## ARCHITECT'S SUPPLEMENTAL INSTRUCTIONS

PROJECT: The Reserves at Magnolia New Apartment Complex  
Denton, TX

Report No. Five (5)

Date June 24, 2025

A3.1

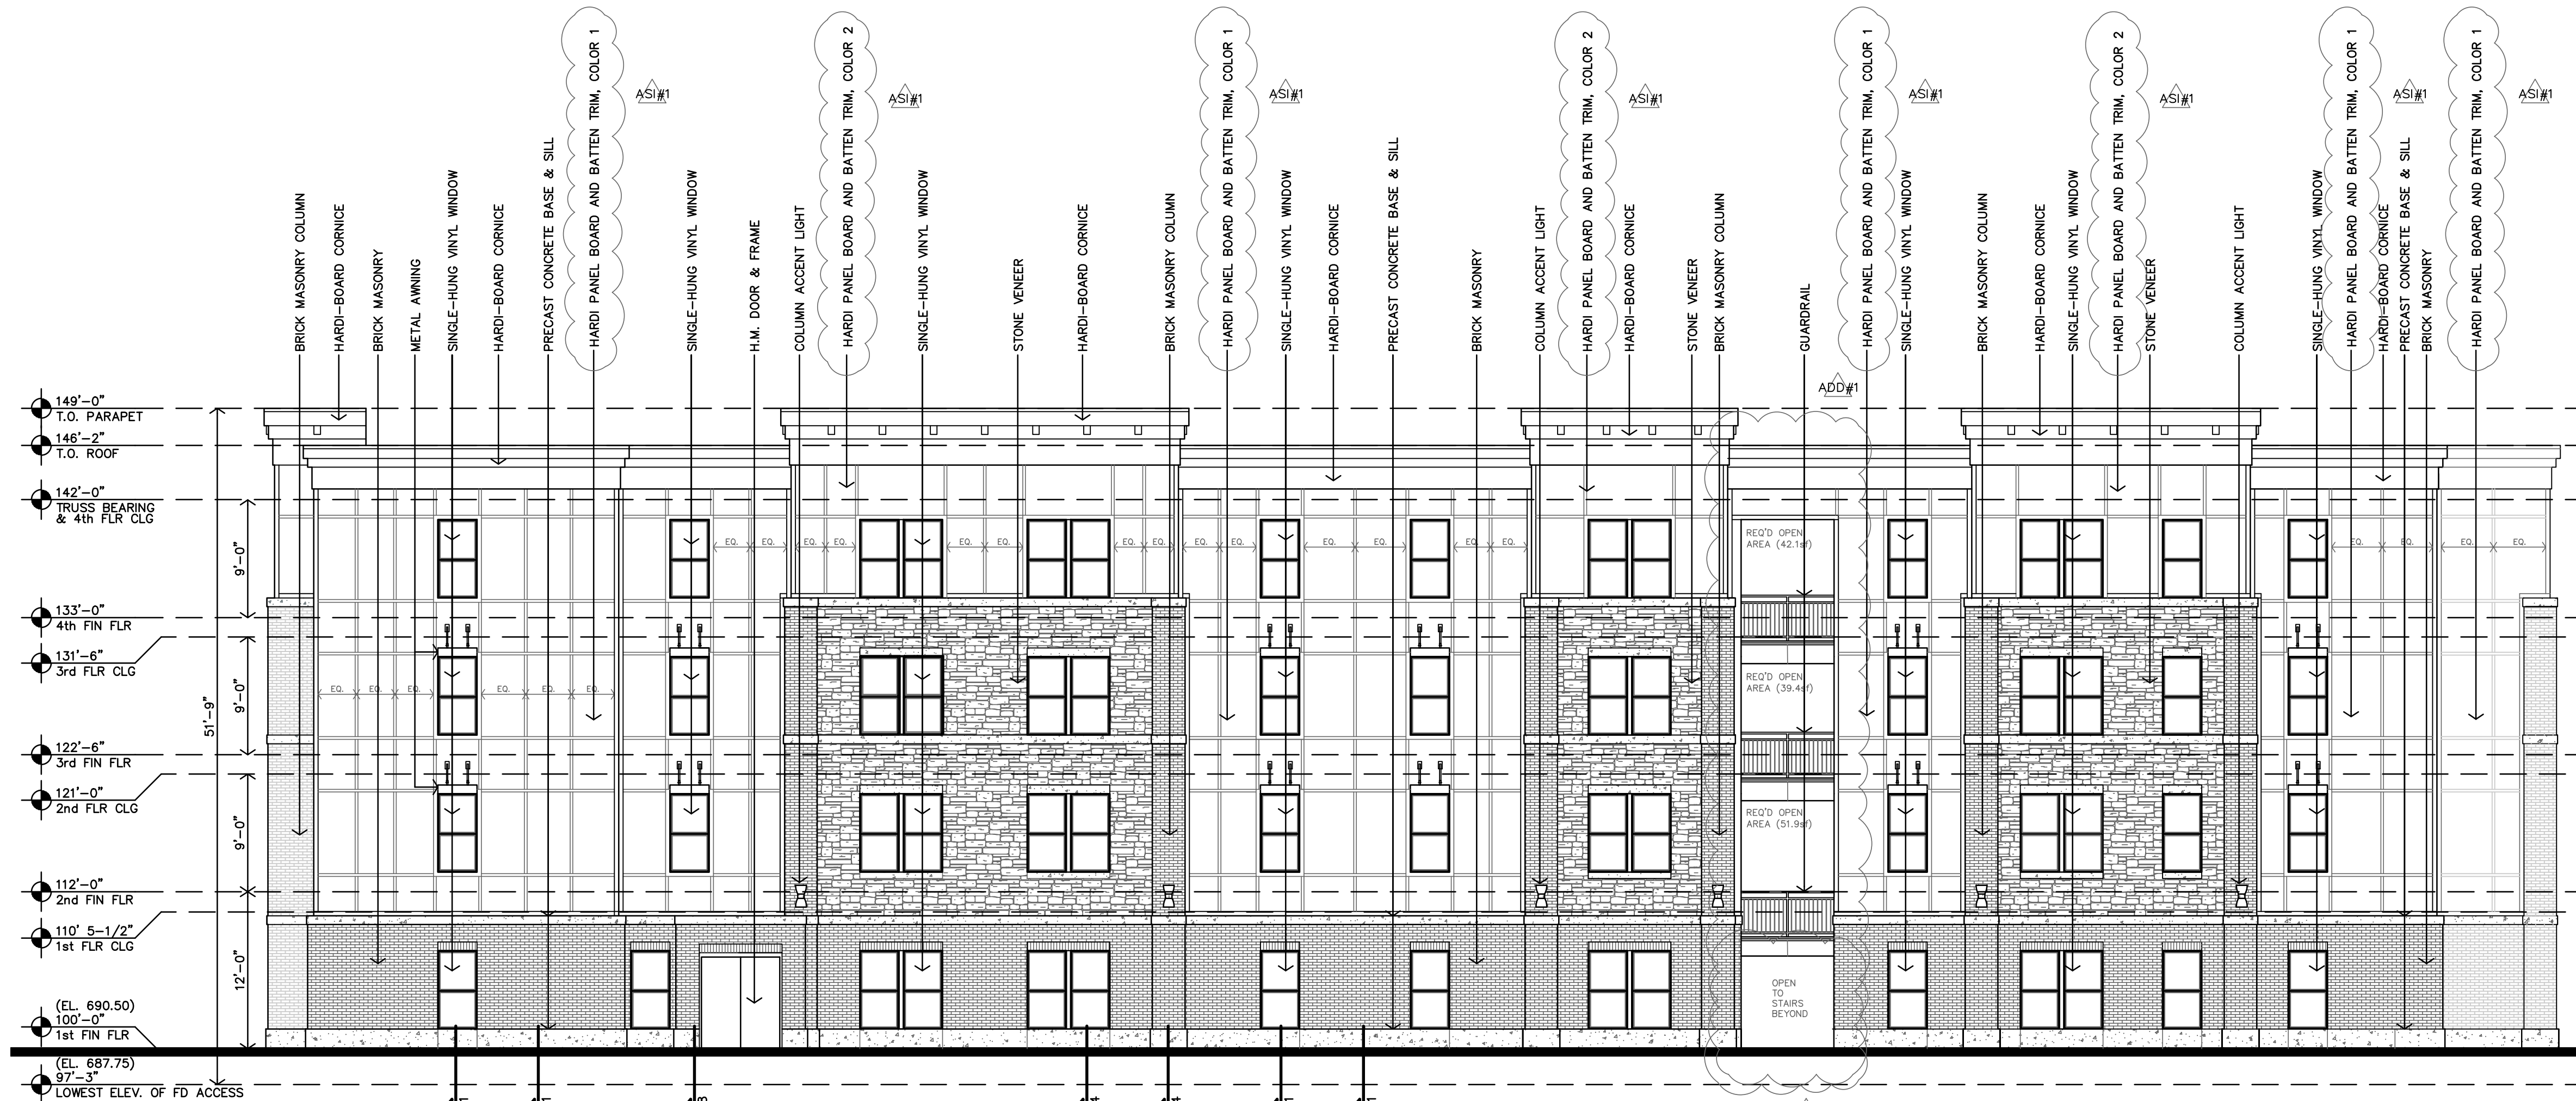
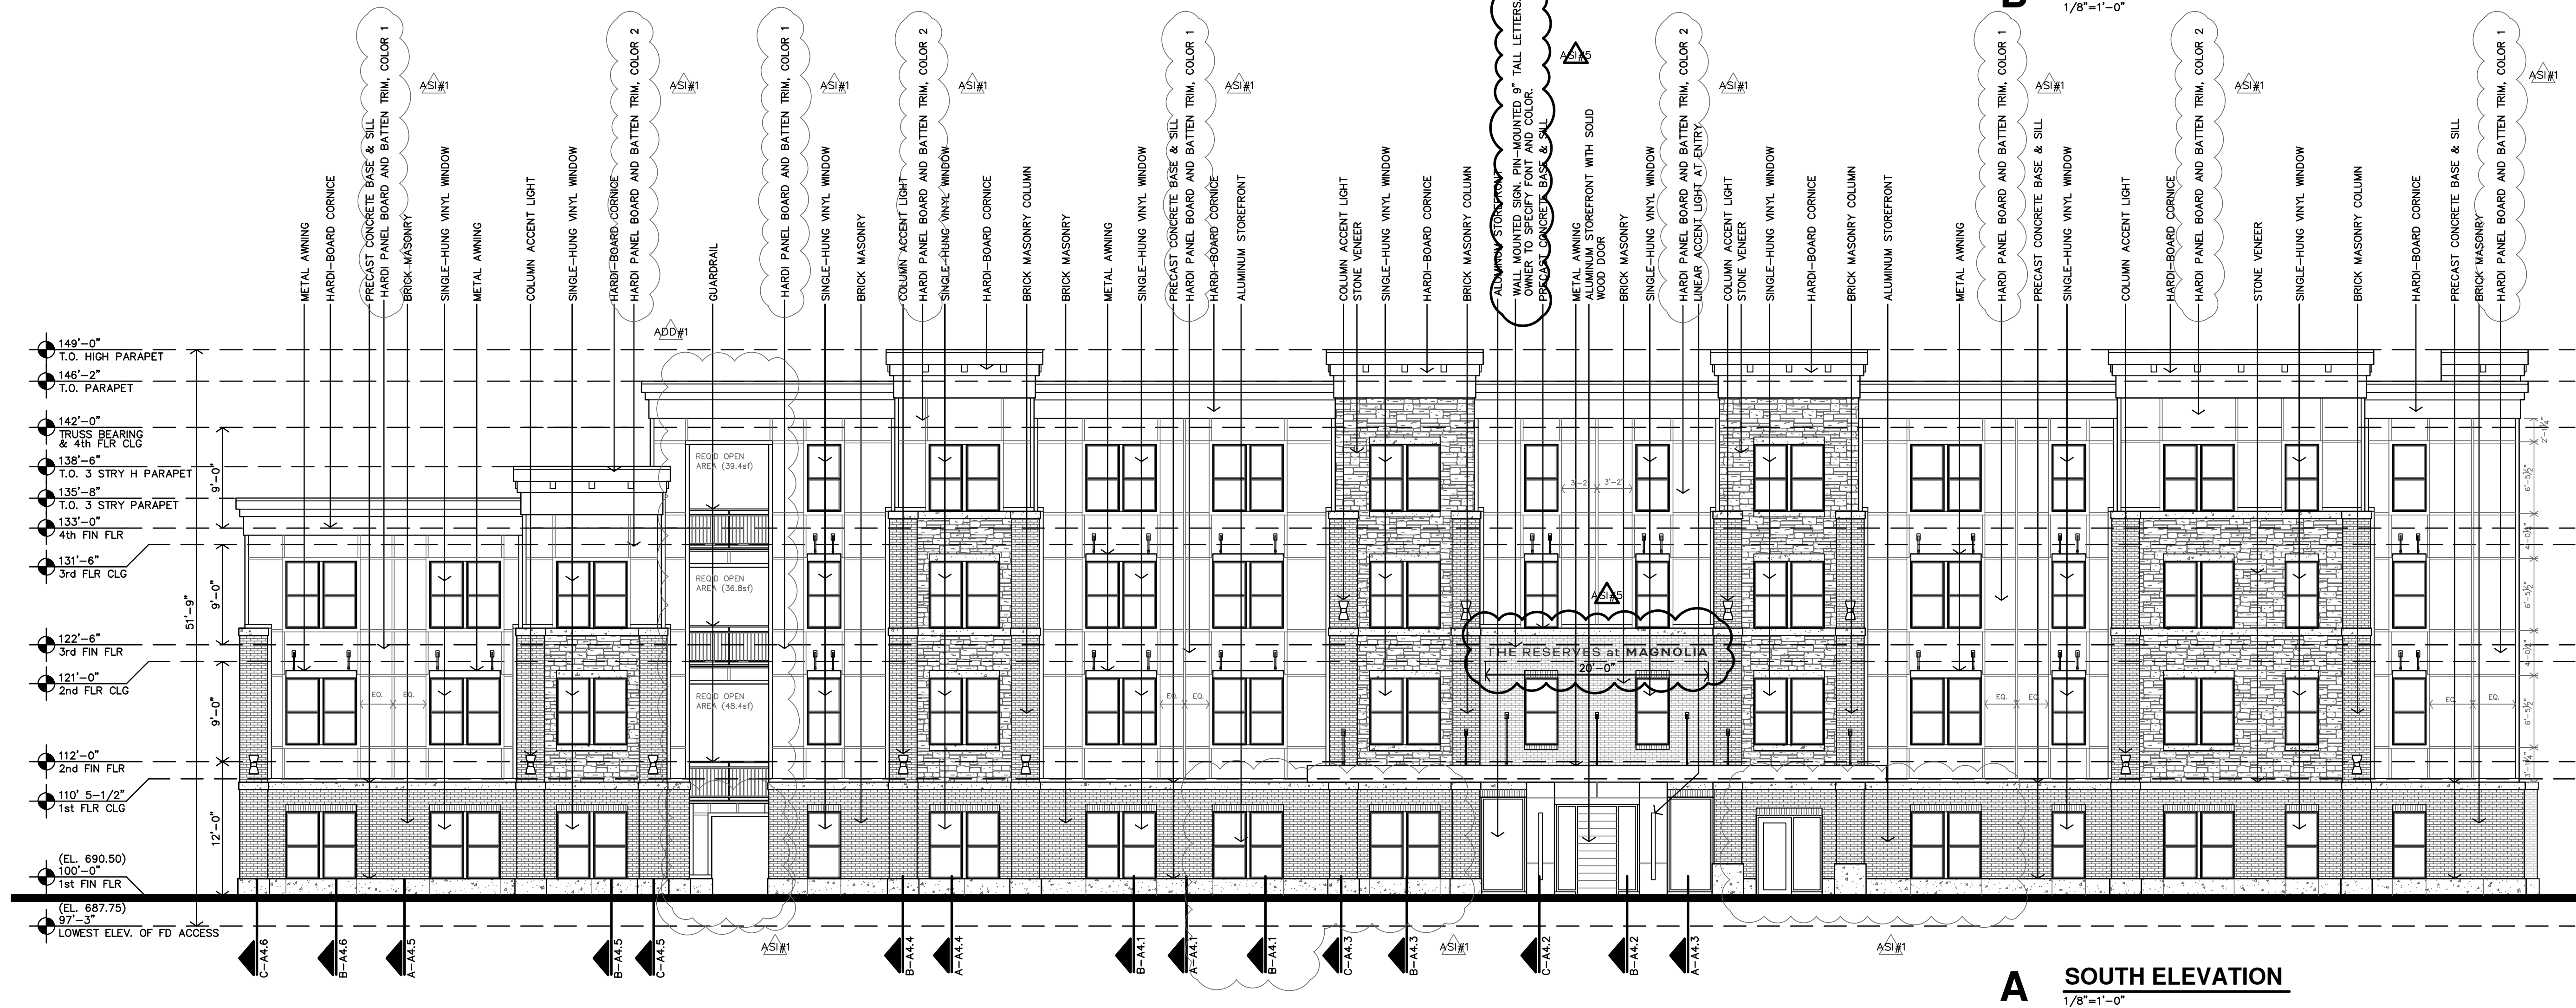
- 1) Install a wall mounted sign on the south side of the building, above the entry. The sign shall be pin-mounted. Material and attachments per manufacturer. Font type and color shall be coordinated with owner.

Note: Confirm font type/style and color with owner.

20'-0" max.

9" tall letters
